RECEIVED
JUN 12 1998
RESUBMIT APPROVED
BY *James M. [Signature]* DATE *6/12/98*

HIGHWAY SAFETY CORP.
Glastonbury, Connecticut

ITEM 525.44 BRIDGE RAILING - HDSB
ESSEX
VT 128 OVER BROWNS RIVER

DRAWN	PAR
CHECKED	CMM
DATE	05/29/98
SCALE	N.T.S.
REFERENCE NO.	1057
SHEET NO.	2 OF 2

SPECIAL WASHER DETAIL

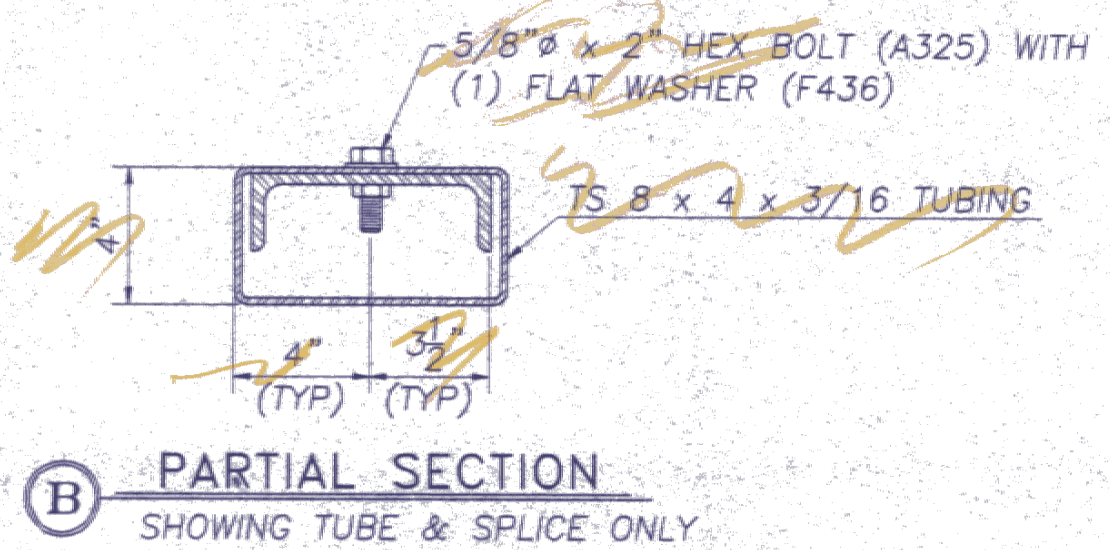
*Ask Shanna
ok
Supplied by
F.R. Lafayette*
